UNITED STATES PATENT AND TRADEMARK OFFICE

APPLICATION NO.	FILING DATE	FIRST NAMED INVENTOR	ATTORNEY DOCKET NO.	CONFIRMATION NO.
10/780,723	02/19/2004	Hiroshi Saitoh	X2007.0150	3284

Office Action Summary

DETAILED ACTION

The Millet disclosure FIG. 1G. showing the lead frame.

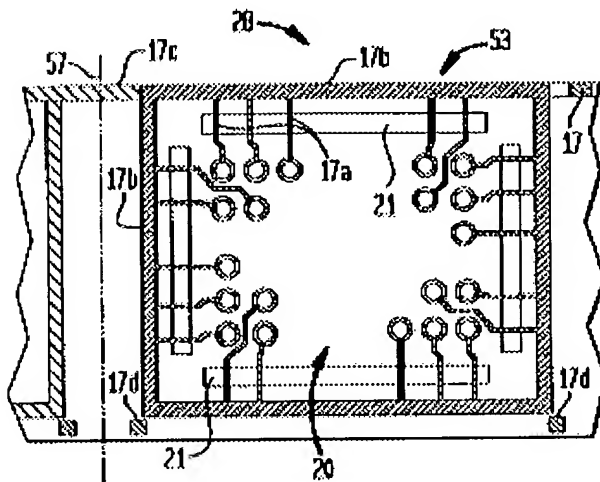
6. Pertaining to claim 17, Millet discloses a manufacturing method for a semiconductor device comprising the steps of:

pressing a metal material 17 to produce a lead frame 28 that comprises a plurality of outer frames

17c and 17b, a plurality of electrode supports 17a connected with the plurality of outer frames,

and a plurality of electrodes 19 respectively supported by the plurality of electrode supports;

drawing the plurality of electrode supports to be lowered in position compared

with surfaces of the electrodes and at least a part of the outer frames;

forming a lead frame assembly in which a semiconductor chip (not shown) is electrically

connected with the plurality of electrodes. However, Millet fails to disclose

The Perez disclosure showing resin 66.

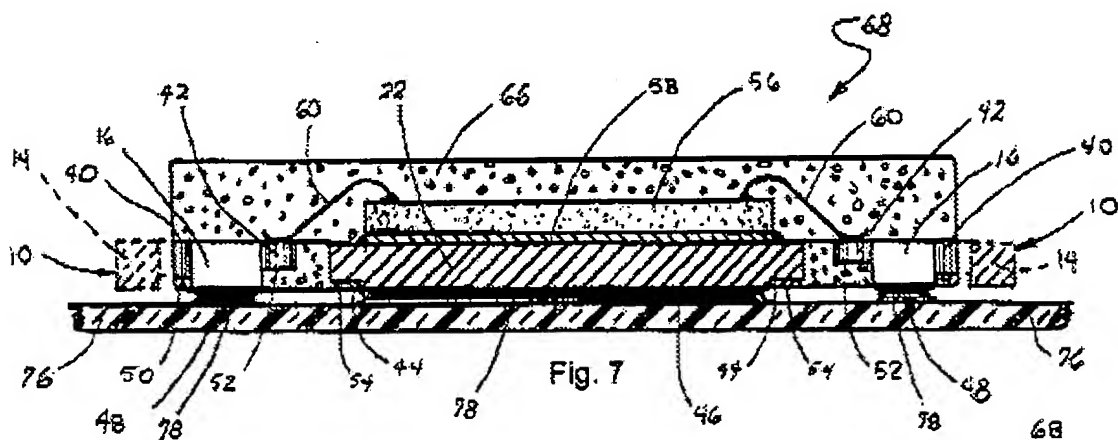
electrodes from each other. Perez discloses enclosing the lead frame assembly within a resin

package in such a way that the surfaces of the electrodes are exposed to a surface of the resin

package; and

cutting at least a prescribed part of the electrode supports so as to separate the plurality of

electrodes from each other. In view of Perez, it would have been obvious to one of ordinary skill

in the art to incorporate a resin into the semiconductor package of Millet because the resin forms

a protective body over the die (column 5, lines 30-35).
